SHOP DRAWING REVIEW

HIGHWAY SAFETY CORP.

ITEM 621.73 - BRIDGE RAILING - NETC 4 RAIL

CITY OF SOUTH BURLINGTON
US ROUTE 2 OVER I-89 @ EXIT 14
IM DECK(36) BRIDGE #68

SECTION C-C (CONNECTION PLATE)

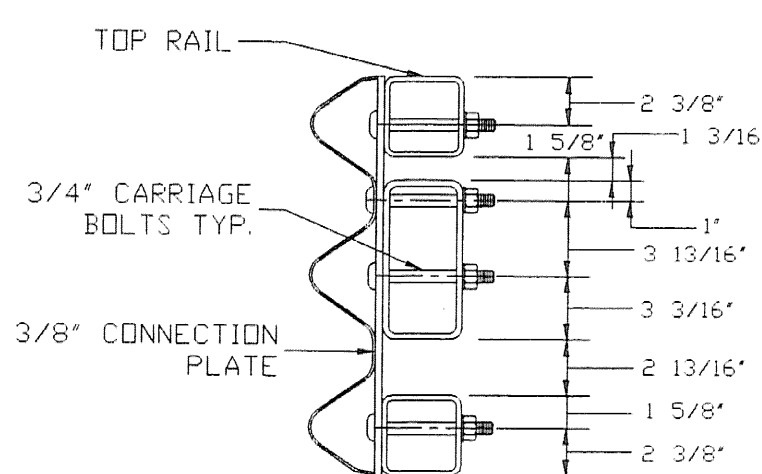
Verify ~~these~~ these dimensions with
in detail
